Landscape Referral Response

Application Number:	DA2025/0150
Date:	04/04/2025
Proposed Development:	Demolition works and construction of a dwelling house including swimming pool
Responsible Officer:	Anaiis Sarkissian
Land to be developed (Address):	Lot 19 DP 8698 , 77 Central Road AVALON BEACH NSW 2107

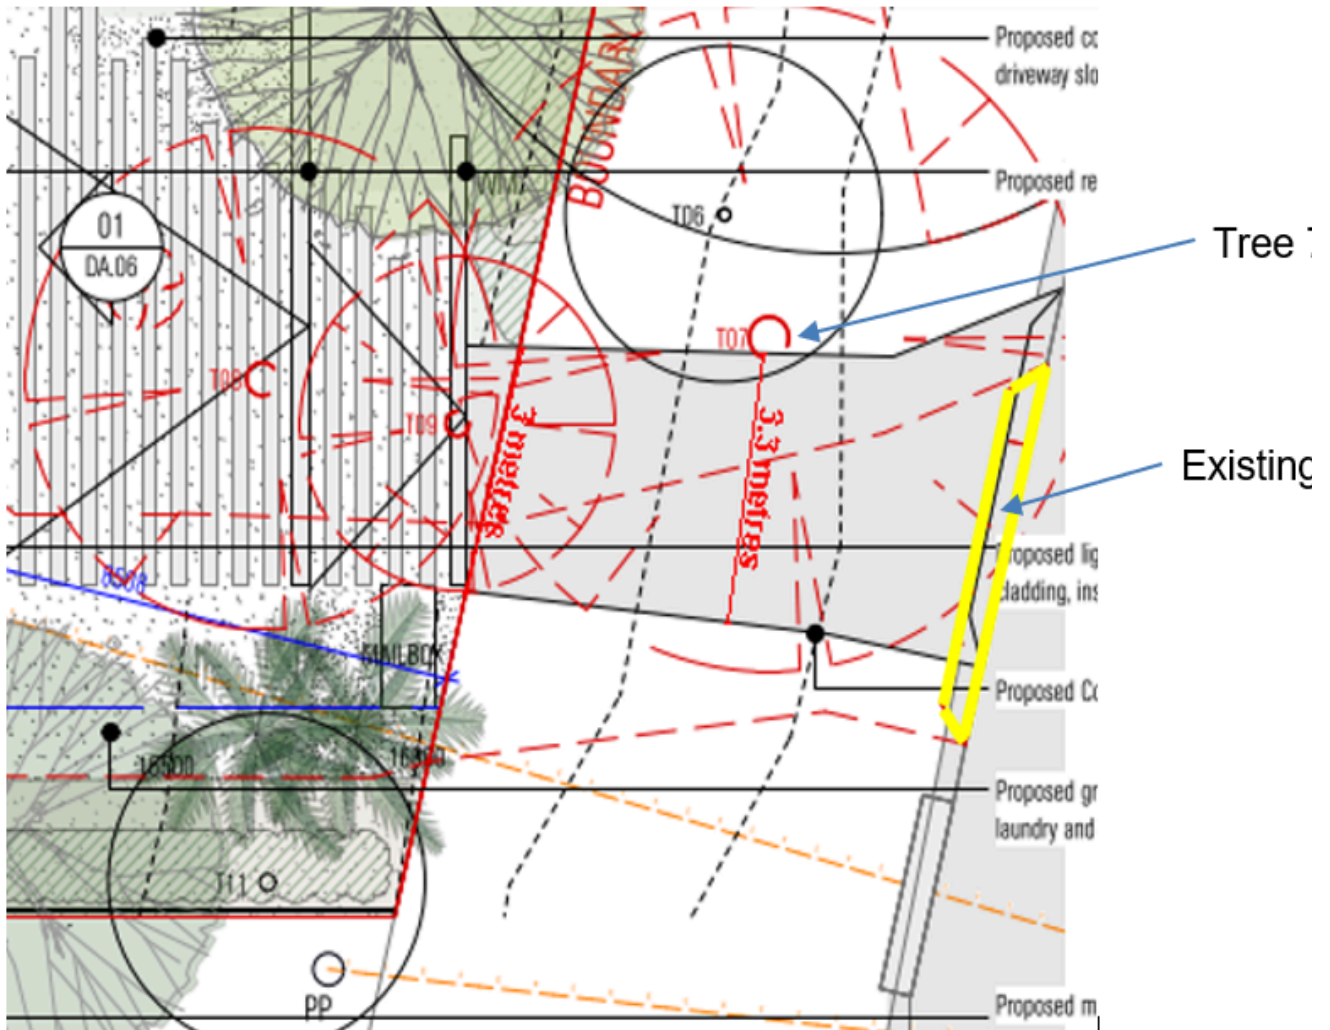
The Arborist's Report indicates that four exempt trees and one non-exempt tree are required to be removed to accommodate the new crossover and driveway. No objections are raised to the removal of the exempt trees.

The non-exempt tree to be removed, Tree 7 *Eucalyptus resinifera*, is located within the Central Road road reserve, adjacent to an existing layback and crossover.

Tree 7 is described as of Medium landscape significance and High retention value.

Tree 7 forms part of a significant streetscape along Central Road, dominated by tall native trees.

New crossover above existing ground levels

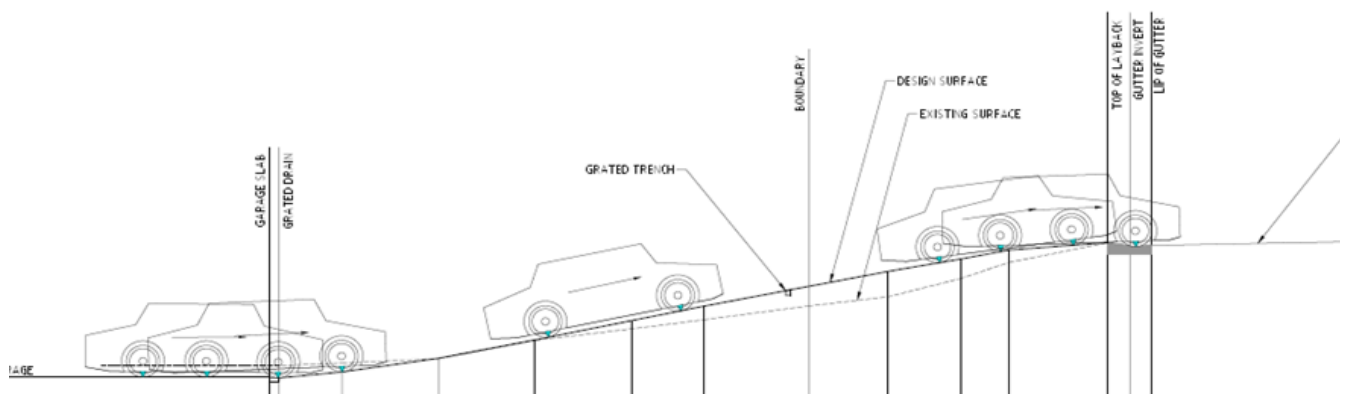
The plans indicate that the tree would be immediately adjacent to the new driveway crossover. It is noted that the proposed crossover is located closer to the tree than the existing crossover.

The Driveway Long Section provided by Intrax indicates that the driveway is to be constructed above existing levels to achieve compliant grades.

Suggested crossover alignment (Red lines)

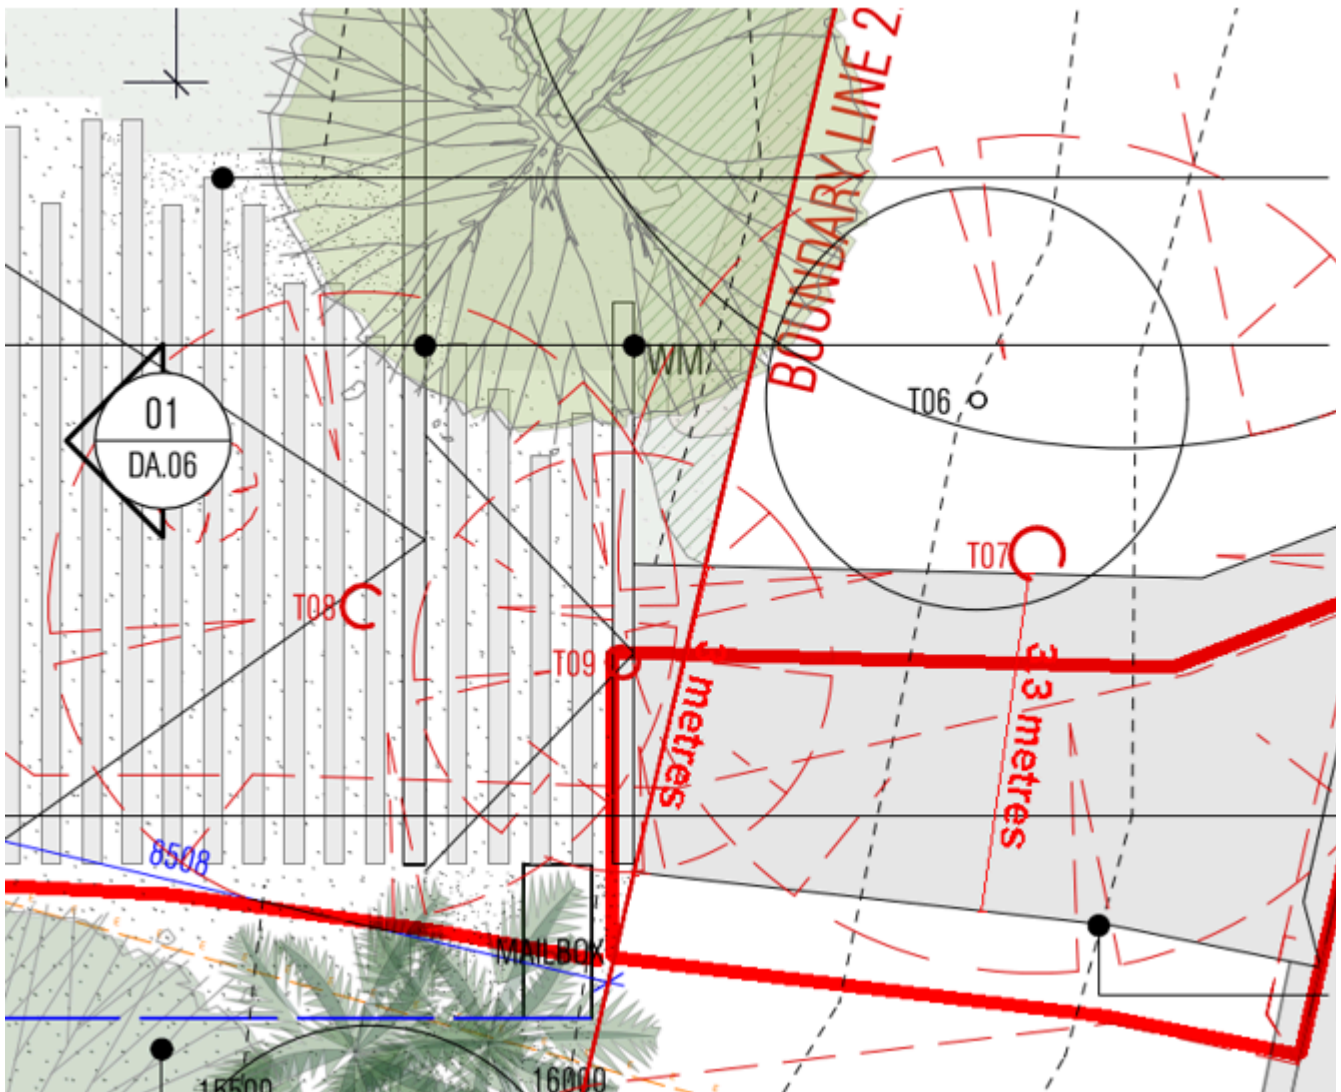
If the existing layback location is maintained the new driveway could be provided clear of the tree trunk, enabling its retention.

As the removal of the tree is not supported and there appears to be an alternate solution to enable retention, the proposal is not able to be supported with regard to landscape issues at this stage.

The amended plans indicate retention of the existing crossover location, reducing impact on Tree 7.
